# LAND USE APPLICATION

Re: Plan Review, 1177 Center St. NE  
15-122543-RP & 15-122545-ZO

The following is a response to your recent, 1-25-16 completeness checklist review of the subject property for a Class 3 Site Plan and Class 2 Zoning Adjustment.

**DAS LANDSCAPE BUILDING**  
 1177 CENTER STREET NE  
 SALEM, OR 97301

**PROPOSED LANDSCAPE PLAN**  
 sheet: **A-100** of.

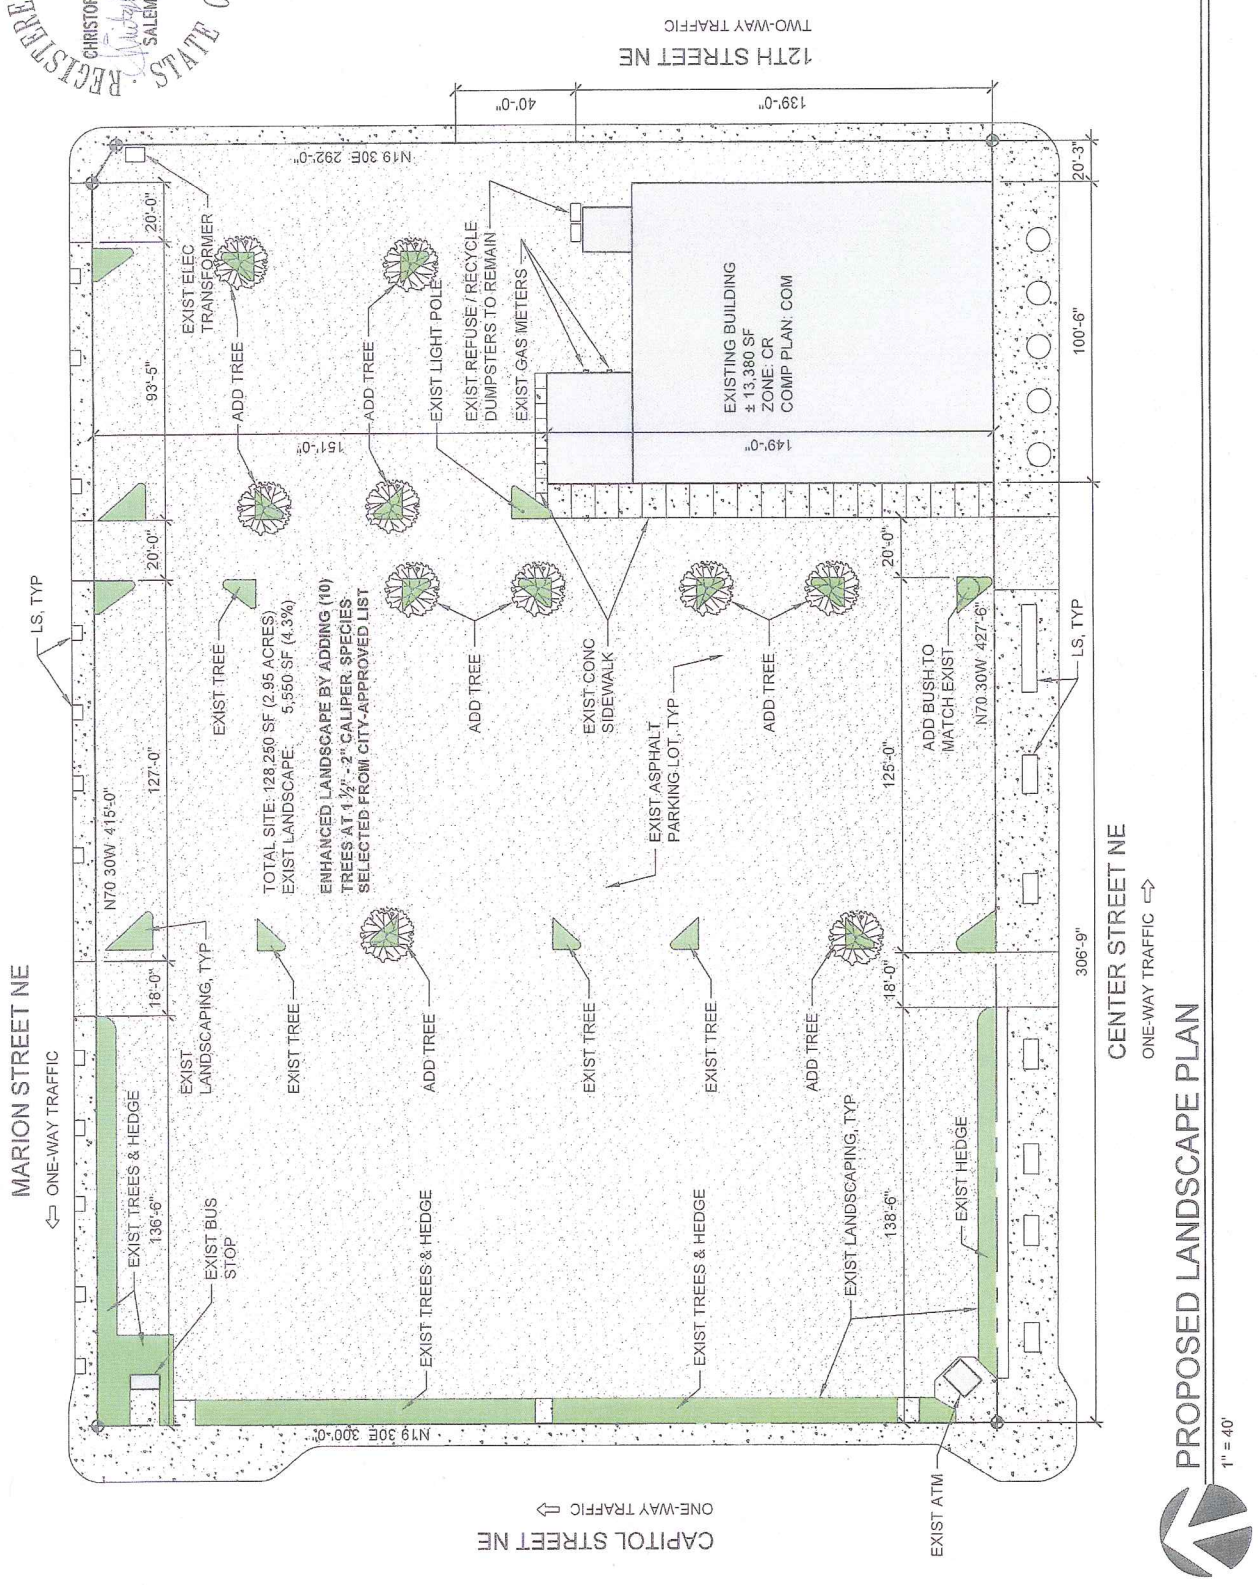
**Item 4:** The submitted written statement states that the new underlying standard of 15% landscaping over a 2.95 acre site is clearly inapplicable to the proposed project because there is no room or available land for more landscaping. The site was developed in 1987 for its maximum use and landscaped to the standards of that time. The use of parking for state employees is just as important as if buildings covered the site. Therefore, to have a standard that requires 15% landscaping to a site that has no room seems inapplicable.

However, in an effort to improve the existing landscaping, this resubmittal shows existing landscape islands to be enhanced with the addition of trees. At ten existing islands that now contain a bush or a missing bush, a new 1-1/2 to 2 inch caliper tree is proposed for that island. The species of tree has not been determined but will be selected from the City approved list in consultation with the DAS Landscape Department, which is the new tenant. With this revision we feel that the site is getting better within the existing allowable area.

TOTAL SITE: 128,250 SF (2.95 ACRES)  
 EXIST LANDSCAPE: 5,550 SF (4.3%)  
 ENHANCED LANDSCAPE BY ADDING (10)  
 TREES AT 1 1/2" - 2" CALIPER. SPECIES  
 SELECTED FROM CITY-APPROVED LIST
